Intel[®] StrongARM^{*} SA-1110 Microprocessor

Specification Update

April 2001

Order Number: 278259-022

Figure 9-2. Interrupt Controller Block Diagram

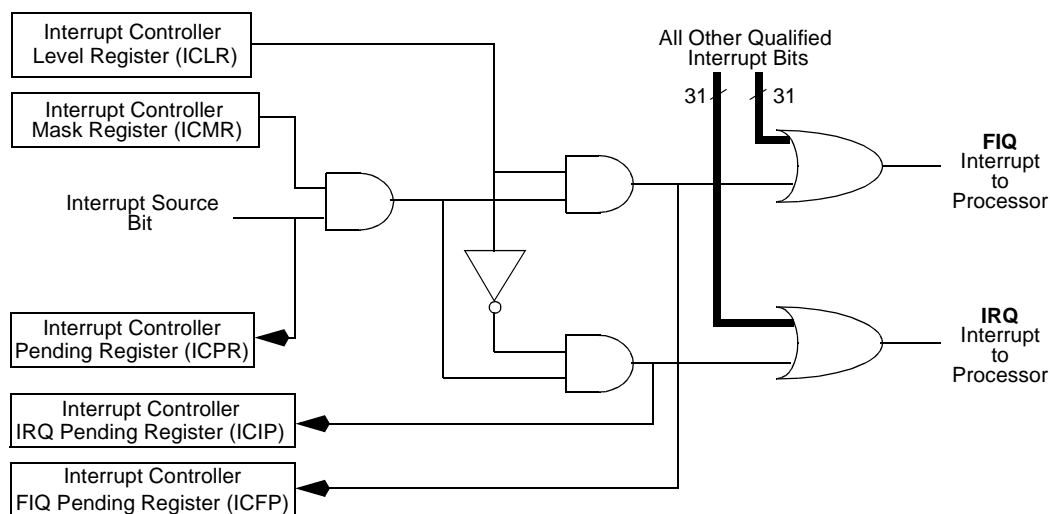
Made the following changes to Figure 9-2.

- Changed Interrupt Level Register to Interrupt Controller Level Register (ICLR)
- Changed Interrupt Mask Register to Interrupt Controller Mask Register (ICMR)
- Changed Interrupt Pending Register to Interrupt Controller Pending Register (ICPR)
- Changed IRQ Interrupt Pending Register to Interrupt Controller IRQ Pending Register (ICIP)
- Changed FIQ Interrupt Pending Register to Interrupt Controller FIQ Pending Register (ICFP)

51. DMA Device Address Register (DDARn): Section 11.6.1.1

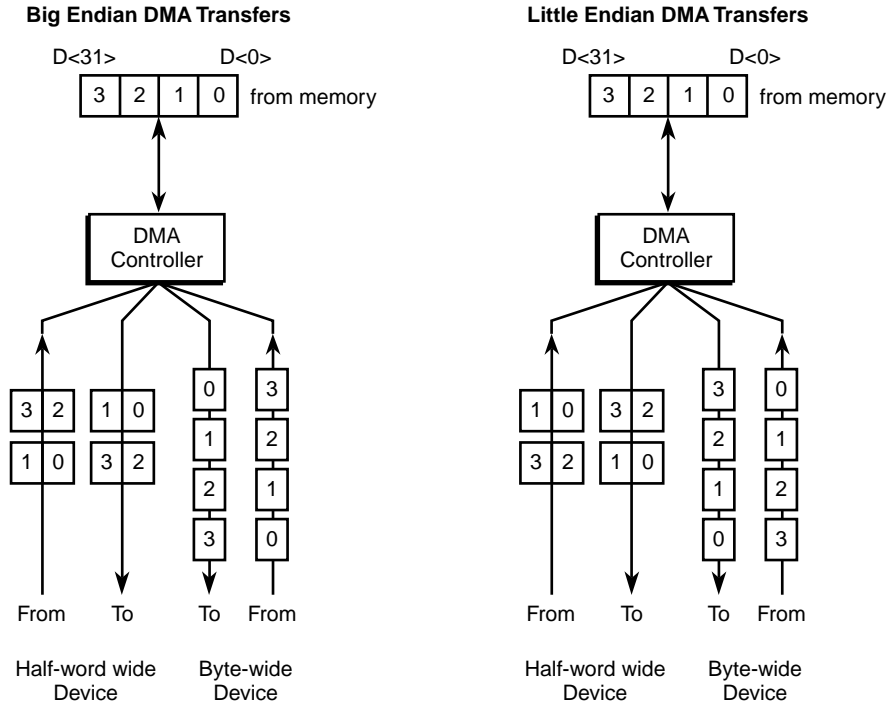
Corrected Figure 11-2.

Figure 11-10. Passive Mode Beginning-of-Frame Timing

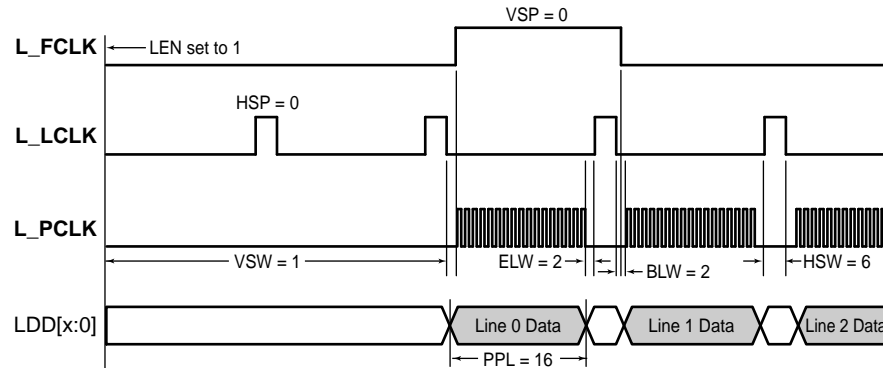
Changed the Notes: in Figure 11-10 to show the range of HSW as 1 to 64, not 0 to 64. The corrected figure is shown below:

Figure 11-11. Passive Mode End of Frame Timing

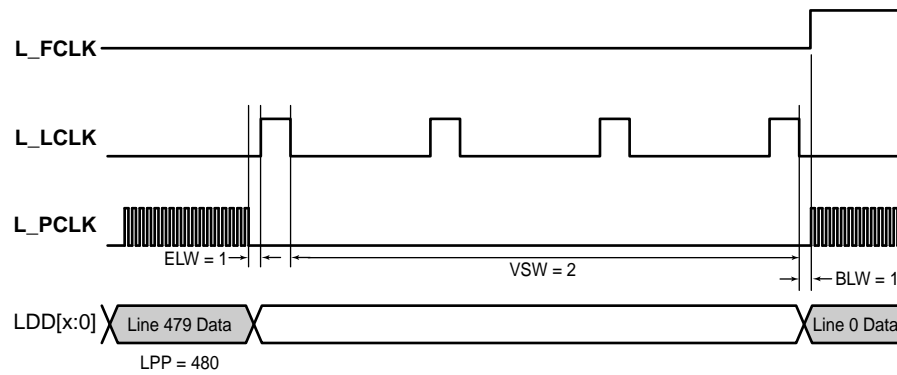
In Figure 11-11 at the location where L_LCLK is deasserted just prior to Line 0 Data, there are two vertical bars depicting BLW = 1. Extended the right vertical bar upward to near L_LFCLK. At this point, changed L_FCLK to show a transition from deasserted to asserted (shown below.)

Also, changed the Notes: in Figure 11-11 to show the range of BLW as 1 to 256, not 0 to 256. The corrected figure is shown below:

Figure 11-13. Active Mode Timing

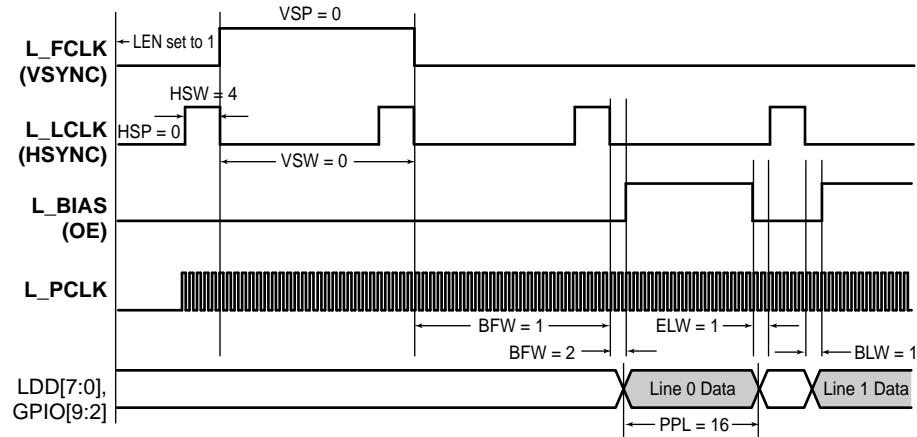
Corrected Notes: in Figure 11-13 to show the range of PPL as 16 to 1024 (not 1 to 1024.) The corrected figure is shown below:
